Application Type: New Right-of-Way Pipeline

One 6-3/4-inch pipeline 0.61 miles long to transport bulk oil from Subsea Well No. 4 through a PLET in Mississippi Canyon Block 711 and looping through Mississippi Canyon Block 755 back to Mississippi Canyon Block 711 "A". Also, an associated umbilical, 1.24 mile long, from the MC 711 "A" looping through MC 755 ending at the PLET in MC 711.

Assigned Right-of-Way Number: OCS-G26866

Assigned Segment Number: 15170 ✓

**GSF Arctic I Mooring Pattern**

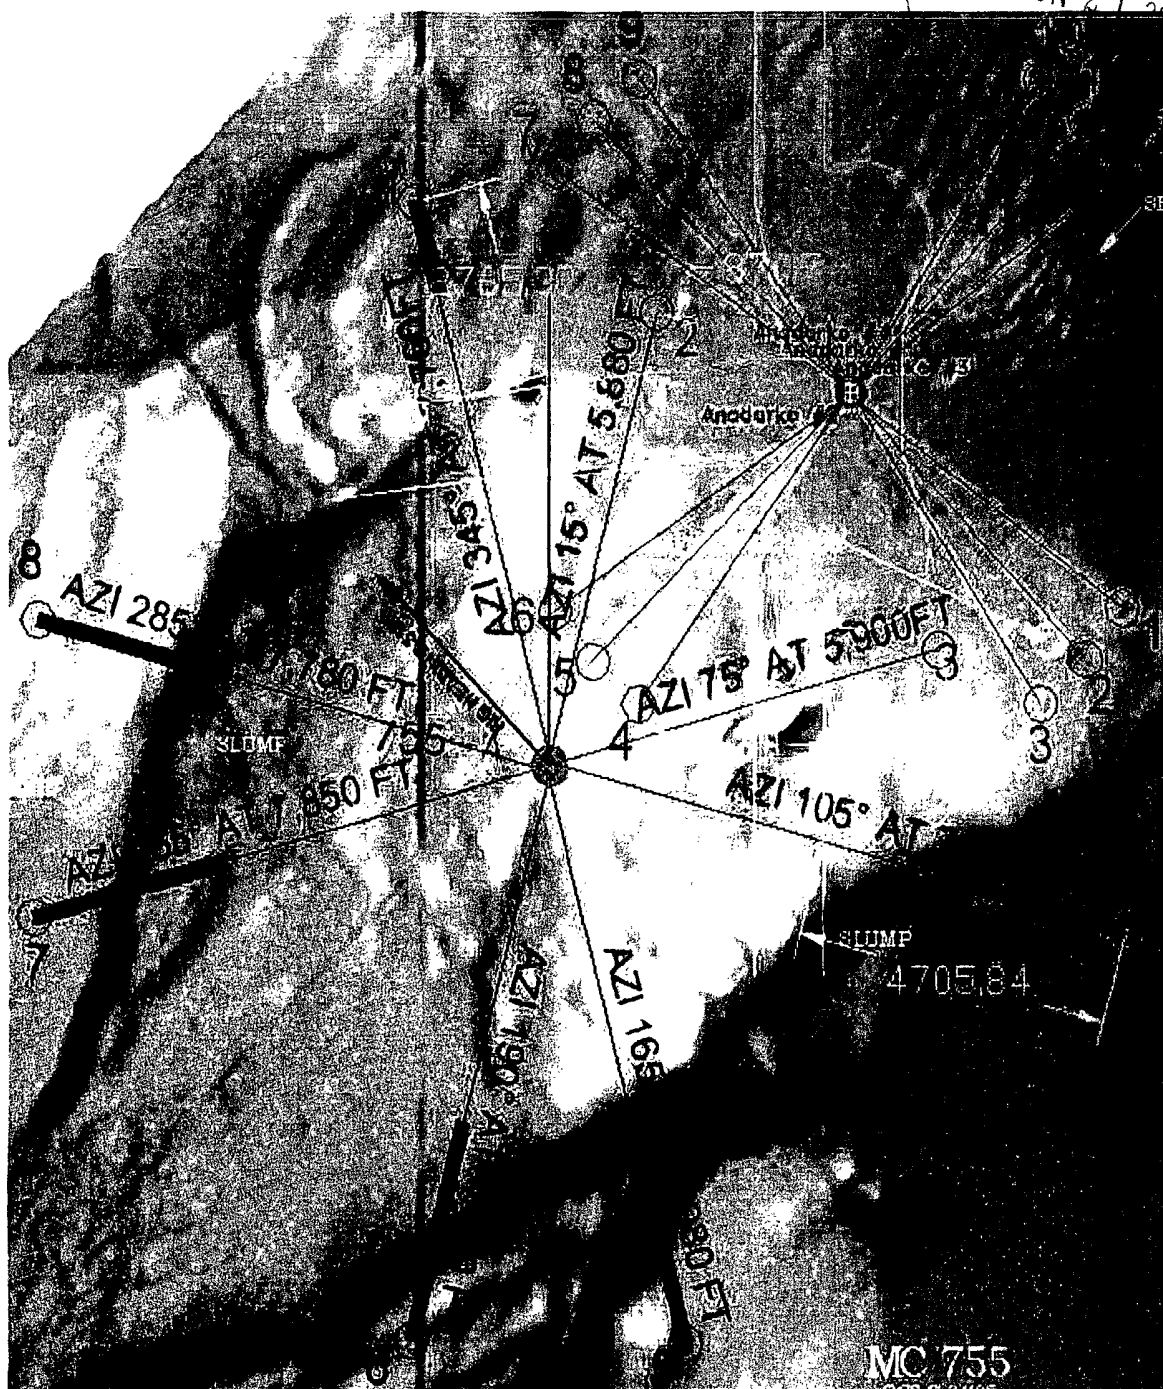
Additionally, Nexen has submitted in their Revised Exploration Plan to drill MC 755 Well No. 3, a proposed mooring arrangement for the "GSF Arctic I" which poses potential conflicts associated with the ATP flowline and umbilical installation proposal. In letters dated June 2, 2005 and June 20, 2005, signed by Larry McRae of Nexen, it was requested that the MMS not approve ATP's proposed plans until both companies could discuss these conflicts.

This letter is a formal response to a proposal letter dated May 23, 2005, from Mickey W. Shaw with ATP Oil & Gas Corporation in which he requested Nexen Petroleum U.S.A. Inc. concur with ATP's proposal for installation of the a 6.895-inch OD bulk oil pipeline and associated umbilical originating at Subsea well No. 006 located on ATP's Lease OCS-G-14016, Mississippi Canyon Block 711. The proposed routing loops onto the northern section of Nexen Petroleum U.S.A. Inc. Mississippi Canyon Block 755 Lease OCS-G-24105 and comes into close proximity of the existing Well No. 2. After careful consideration of all of the issues surrounding this proposal, we regretfully inform you that Nexen will strongly oppose ATP's proposed application as it currently exists.

evaluated and it is our intent to work towards a win-win solution for both parties. This will require considerable effort and cooperation from both parties and will include reduction of safe zones and careful SIMOPs planning. We have included a proposed mooring arrangement for the "GSF Arctic I" which illustrates the potential conflicts associated with the flowline and umbilical installation.
